Draft decision

CitiPower electricity distribution determination

1 July 2026 – 30 June 2031

Attachment 3 – Operating expenditure

Figure 3.3 Econometric opex efficiency scores and opex MPFP, 2006–23

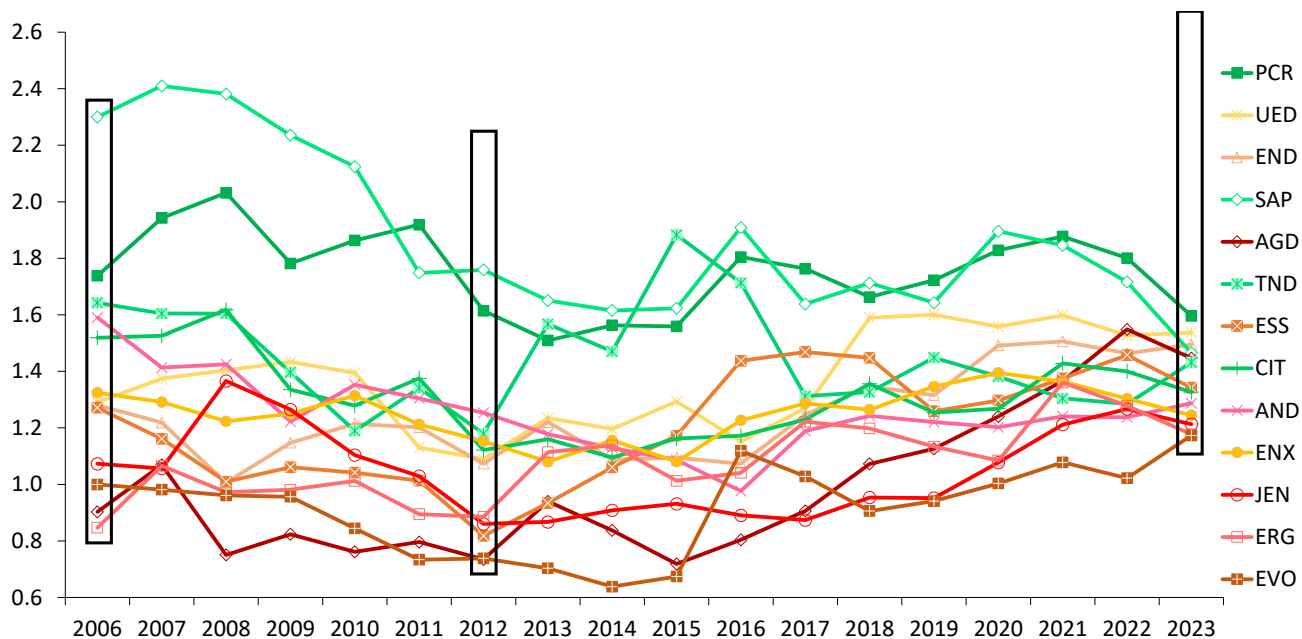
Our benchmarking results indicate that CitiPower has been amongst the more productive and efficient distributors in the National Electricity Market (NEM). Our recent 2024 Annual Benchmarking Report shows CitiPower continues to perform well, relative to other distribution businesses in the NEM.¹³ In particular, as shown in Figure 3.3 for the 2006–23 period, CitiPower remains a benchmark comparator business, with an econometric model-average score across the 2006–23 period of 0.86 and the 2012–23 period of 0.74, which are, on average, above our benchmark comparison point of 0.75.

We consider that these results warrant the use of revealed costs in 2024–25 as the base year in our alternative estimate, as it provides a not materially inefficient base from which to form the 2026–31 period opex allowance.

Figure 3.6 CitiPower's vegetation management opex (\$million, 2025–26)

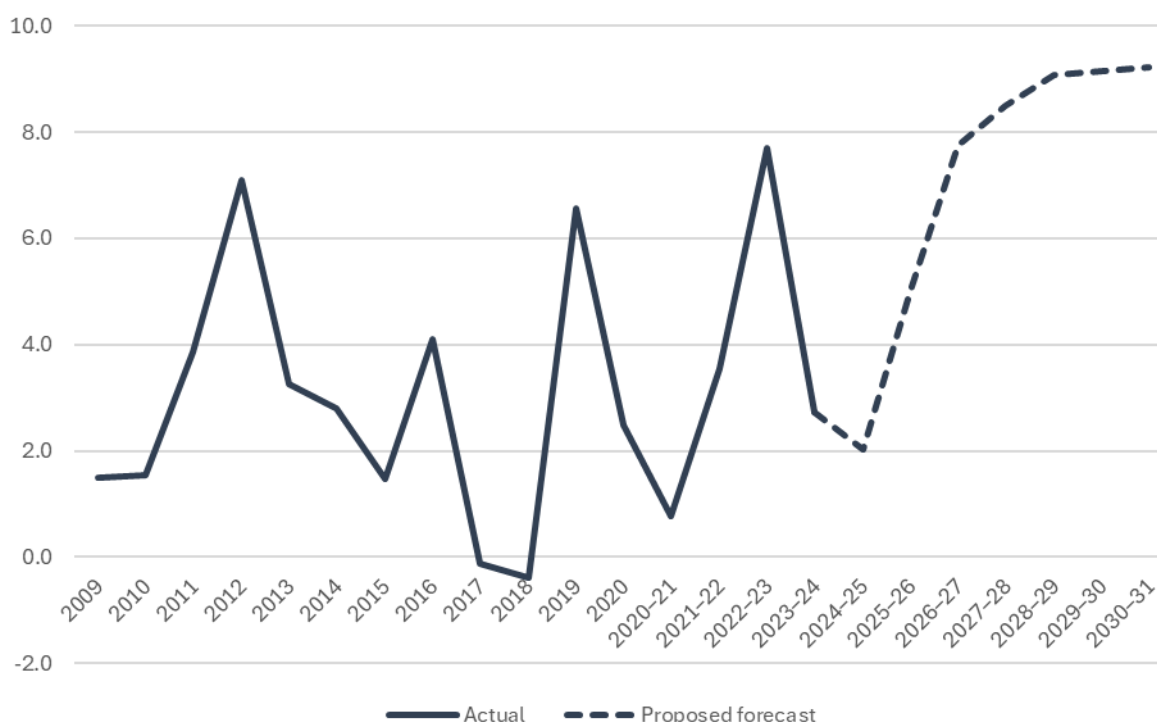
2009. CitiPower's actual opex is volatile and varies significantly from year to year. This includes reporting negative vegetation management opex in 2017 and 2018. It is not clear that CitiPower's vegetation management opex has increased to address the non-compliance that became apparent when it began using LiDAR to inspect vegetation clearances.

CitiPower's forecast vegetation management opex for the 2026–31 period is 108% more than its actual and estimated vegetation management opex for the 2021–26 period, and 245% more than the 2016–2020 period.

Figure 3.7 Spans cut and remaining, 2022 to 2024

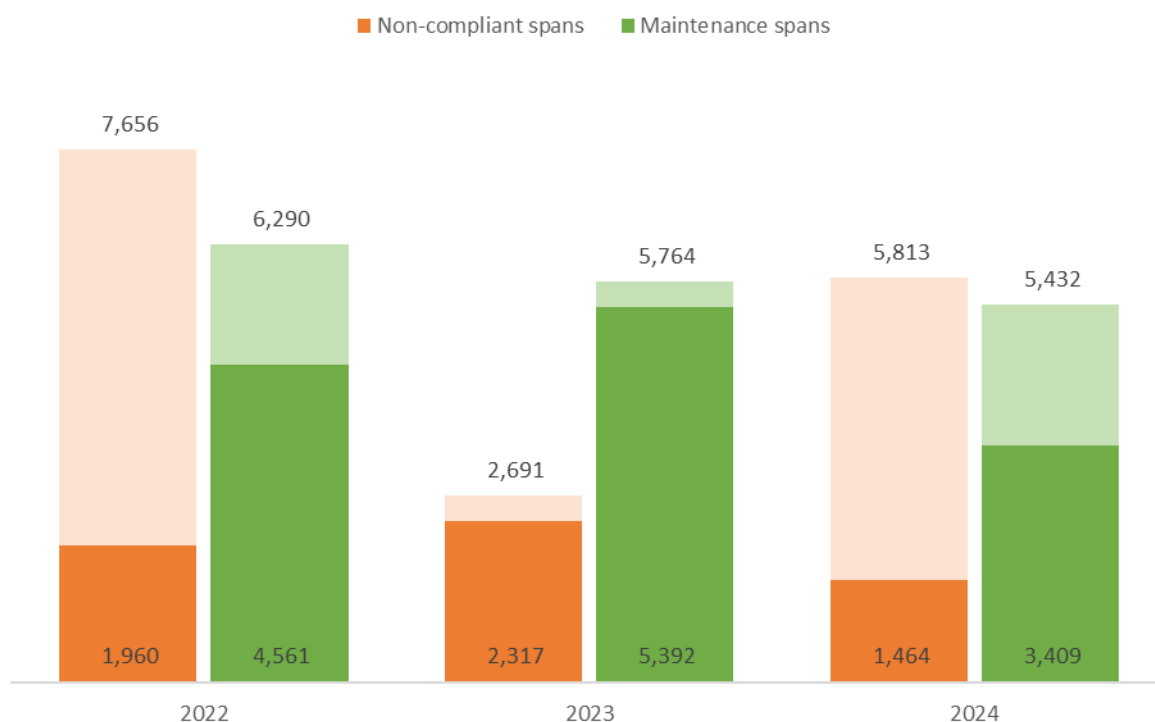
We show CitiPower's cut volumes in Figure 3.7, which shows the number of cuts made and the number of remaining uncut spans. We separately show maintenance cuts and cuts to rectify non-compliant spans. We can see the number of cuts made and cuts remaining vary significantly from year to year. The darker shaded columns in the stacks represent the cuts made. The lighter shaded columns reflect the spans that remained uncut at the end of the year.
